TITLE: PUBLIC HEARING: Subdivision Permit and Plat for Wildflower Meadows,

2<sup>nd</sup> Filing, Laramie County, WY.

PA-25-00059

Project Description: TWO TRACT REPLAT FOR RESIDENTIAL USE

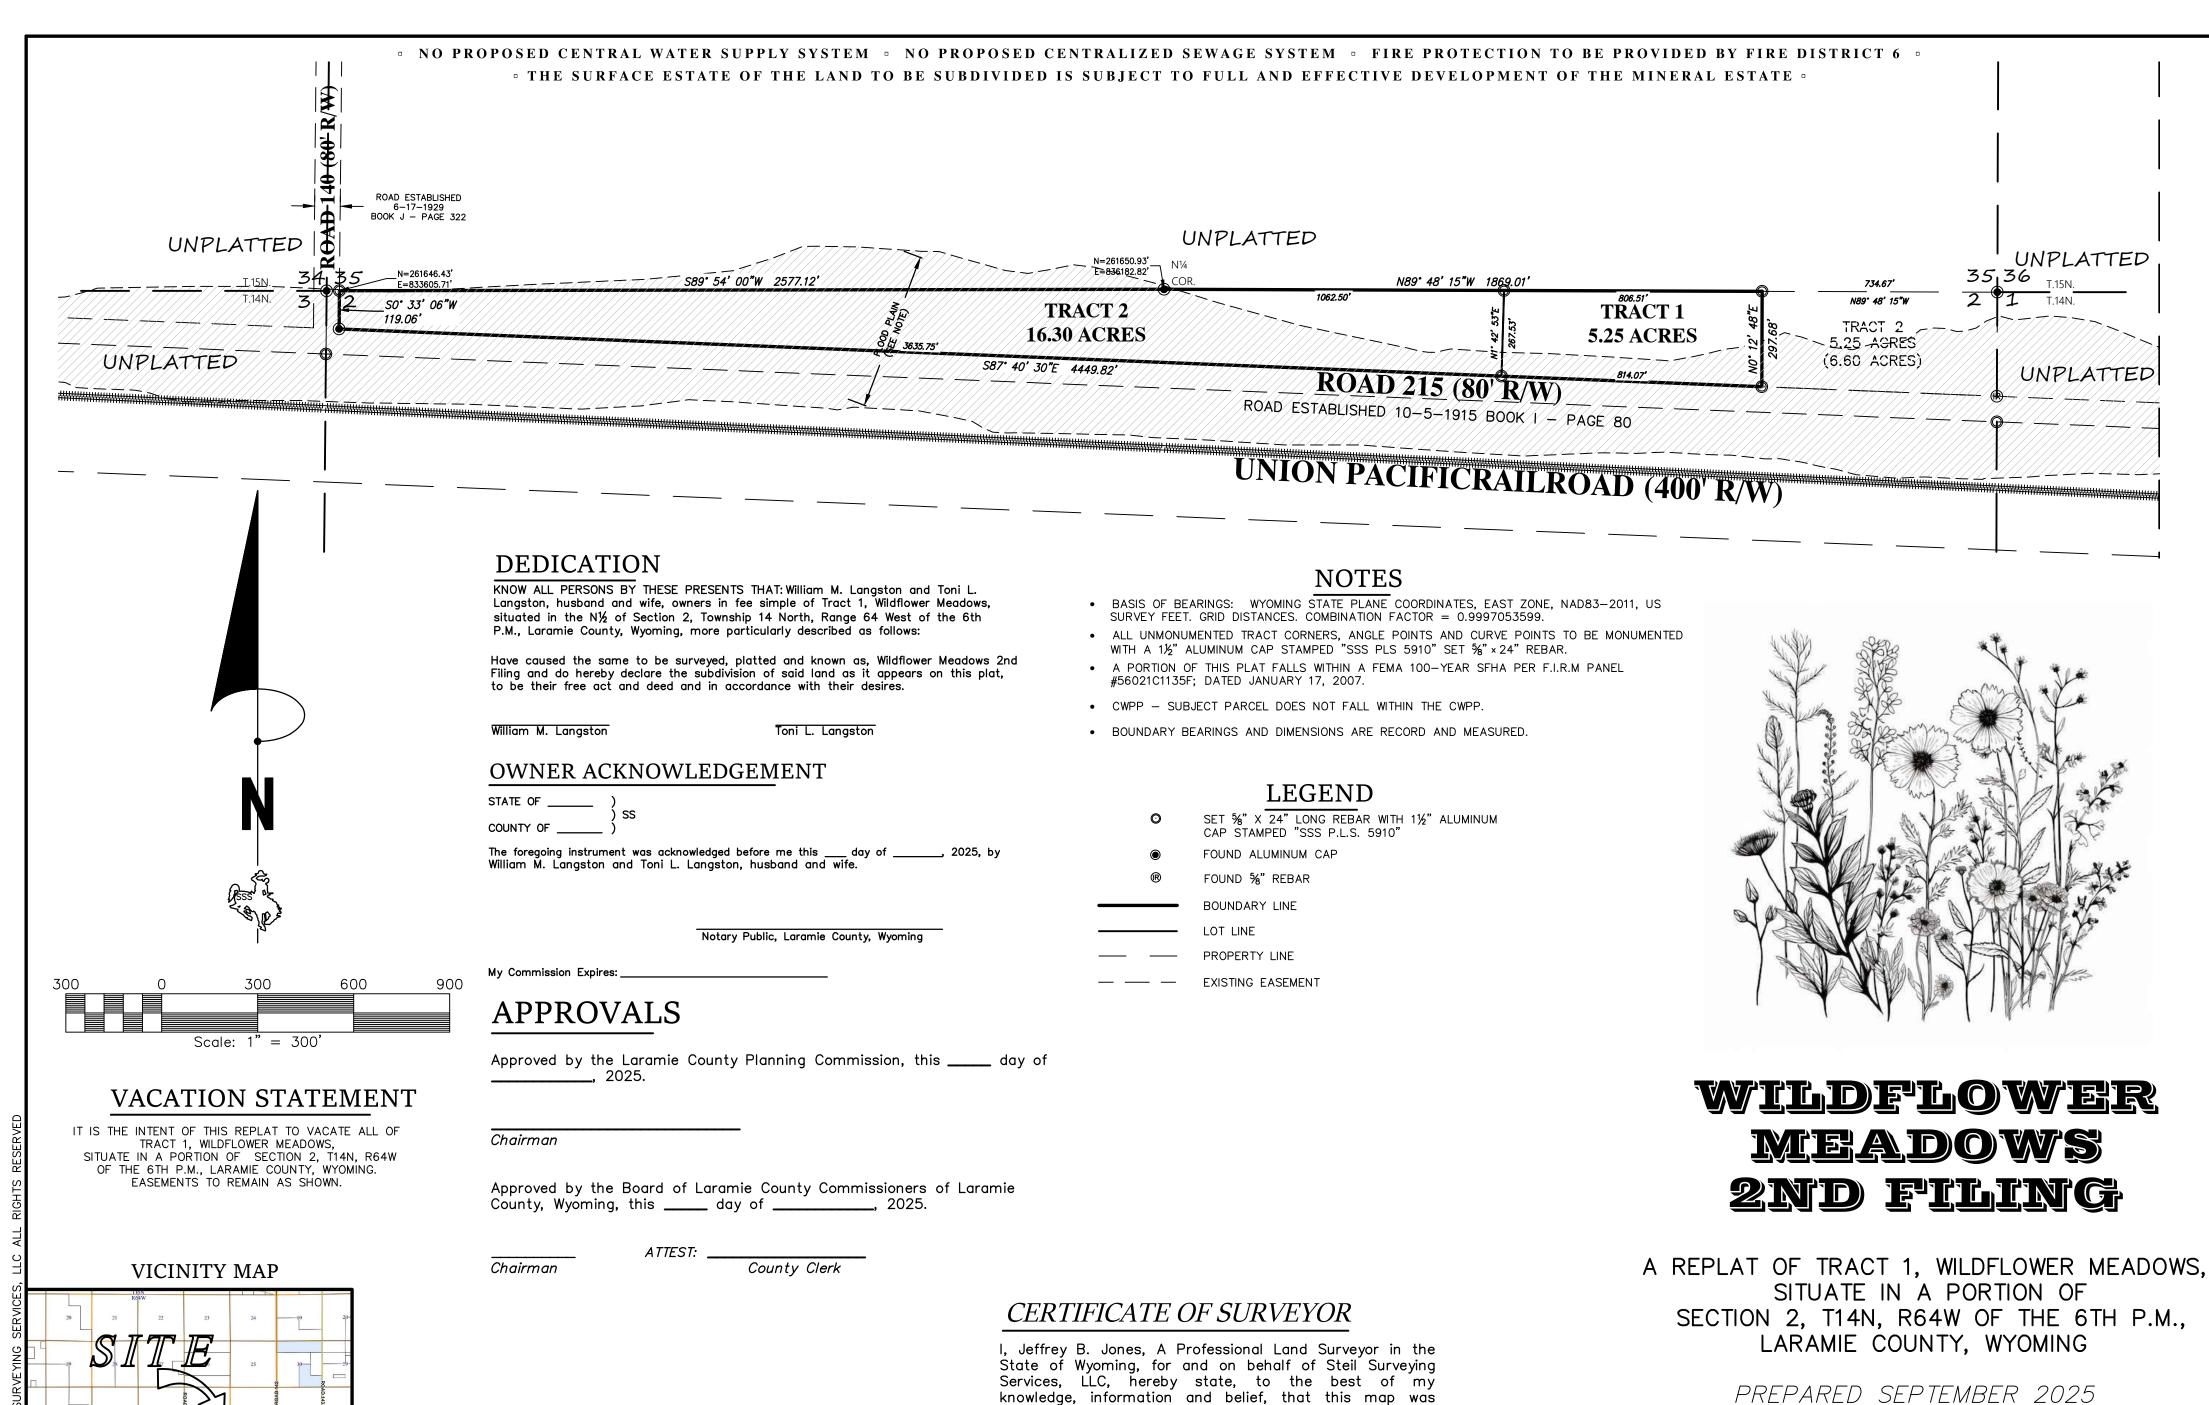
<u>.</u>	Application d DED BY JUSTIN	PZ-25-00065	GENERAL	1st Review Engineer Comments 1.A Drainage Report is not required for this plat per 5-2-106. 2.A Transportation Worksheet needs to be submitted per 5-6-103. 3.Per 4-5-102.b. the plat drawing shall include the following items: 14.) Plats that show adjacent or internal existing roadways and rights of way shall indicate on the plat how the roadway was established (i.e., dedicated to the public via plat, petition, declared, etc.). How was Road 215 and Road 140 established? 21.) A legend that defines all the various	SCOTT.LARSON@ LARAMIECOUNTY WY.GOV

4. corrected				symbols, line types, shading/hatching, etc. used in the drawing. The legend shown on the plat only defines symbols, but not line types or hatching.  4. There is no bearing listed/shown for the boundary line between Tract 1 and Tract 2, only a distance is shown.	
<ol> <li>corrected</li> <li>added</li> </ol>				Surveyor Comments 1.The legal description in the DEDICATION of this plat is the exact same legal description that is part of the DEDICATION of the original WILDFLOWER MEADOWS plat, which includes TRACT 2 of the original WILDFLOWER MEADOWS subdivision. TRACT 2 of the original WILDFLOWER MEADOWS subdivision is not part of this subdivision. 2.It would be helpful to dimension the tie to the northwest corner of Section 2.	
09/30/2025	Workflow	COUNTY REAL ESTATE OFFICE REVIEW	GENERAL	No Comments	TERESA.LEMASTE R@LARAMIECOUN TYWY.GOV
10/01/2025 ack	Workflow	PUBLIC WORKS REVIEW	GENERAL	Public Works Review #1 under Regs adopted 8.5.25:  1. All comments from the review engineer and/or surveyor shall be addressed and resolved appropriately.	MOLLY.BENNETT @LARAMIECOUNT YWY.GOV

symbols, line types, shading/hatching, etc. used in the
drawing. The legend shown on the plat only defines symbols,
but not line types or hatching.

4.There is no bearing listed/shown for the boundary line between Tract 1 and Tract 2, only a distance is shown.

1.The legal description in the DEDICATION of this plat is the exact same legal description that is part of the DEDICATION of the original WILDFLOWER MEADOWS plat, which includes TRACT 2 of the original WILDFLOWER MEADOWS subdivision. TRACT 2 of the original WILDFLOWER MEADOWS subdivision is not part of this subdivision.

2.It would be helpful to dimension the tie to the northwest corner of Section 2.

10/14/2025	Application	PZ-25-00065	GENERAL	3rd Review Previous comments have been adequately addressed. No further comments at this time.	SCOTT.LARSON@ LARAMIECOUNTY WY.GOV
